Final decision on Transpower's listed project application

Churton Park section of Oteranga Bay to Haywards A Line reconductoring project

Date of decision: 10 October 2018

Figure C1: Results of close aerial surveys in 2015 and 2017

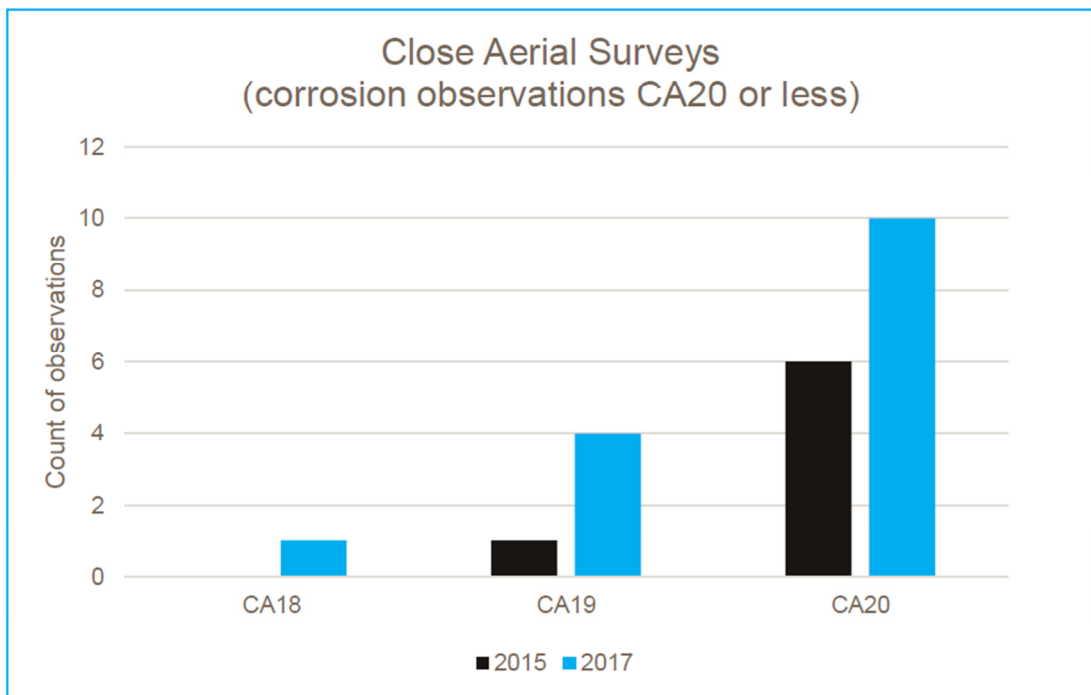
- C33 The close aerial survey uses a helicopter to undertake an aerial survey of transmission lines. This method is used to identify conductor bulges, defects and markers.³⁶ Transpower has undertaken five close aerial surveys since 2012. The results were in Transpower’s application and are replicated in Figure C1 below.³⁷

- C34 The above survey results show material increase in corrosion between 2015 and 2017, affirming that significant conductor deterioration is occurring. Between 2015 and 2017, the number of observations of CA20 or below doubled.^{38,39}

Figure C2: Historical HVDC flow

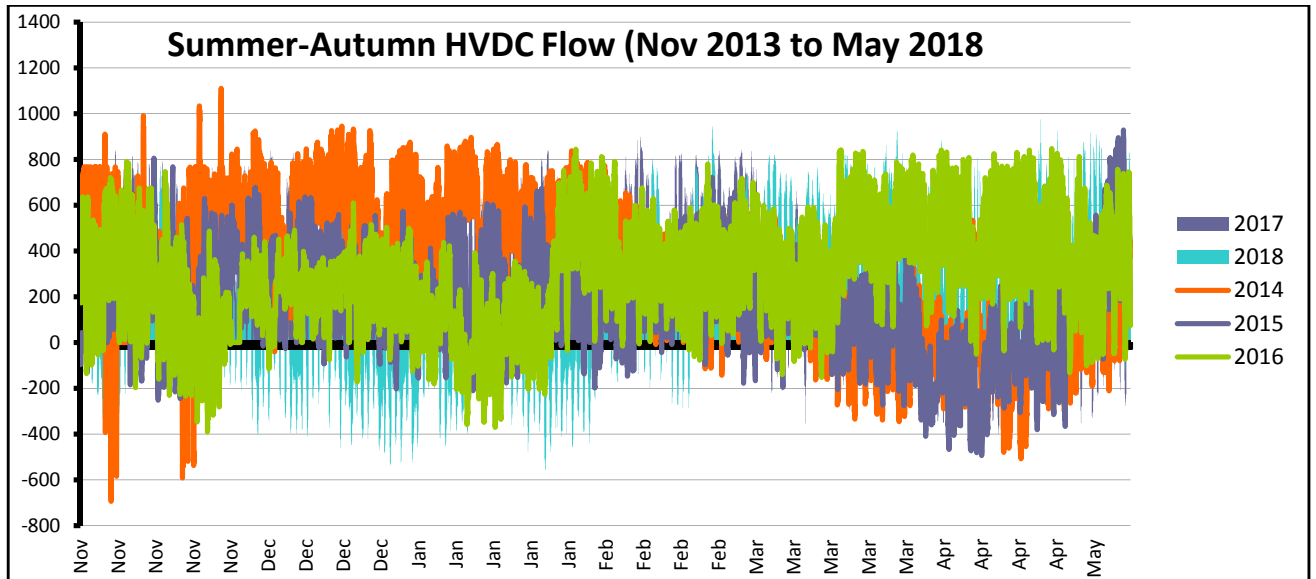
- C85 Transpower's proposed solution is to deliver the project between January and April in 2020. This approach would require an outage of 14 weeks assuming average weather conditions. Transpower's studies concluded that this delivery option, on an economic basis, was the optimal time for construction.⁶⁰
- C86 We agree with this conclusion because the option minimises, and in some instances avoids, the additional costs that would accompany the other options Transpower considered – such as those due to weather related downtimes, splitting the delivery phase, deploying additional resources, and deferring part or the whole of the works. Based on these findings, we are satisfied that the proposed solution will yield the greatest economic benefit.
